Our ref: Mixed Use Development at 17 -24 Loftus Cr, Homebush (SSD-81767963)

Subject: Request for Information

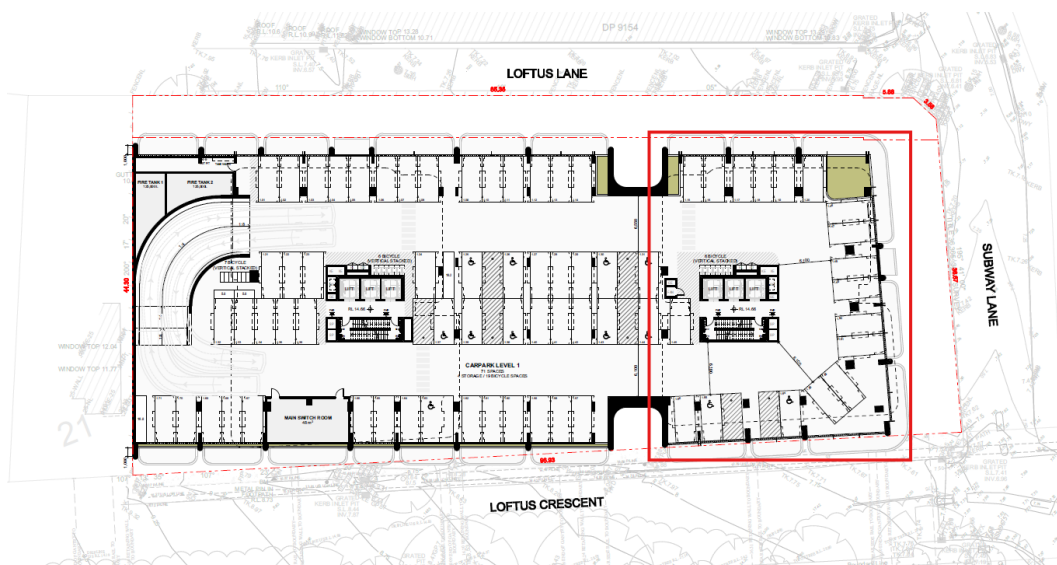
i. Sleeved car parking

To facilitate opportunities for passive surveillance along Loftus Crescent, Loftus Lane and Subway Lane, sleeved car parking should be proposed at the eastern end of the development as identified in red below:

To achieve the above, it is noted that the number of parking spaces may need to be reduced.
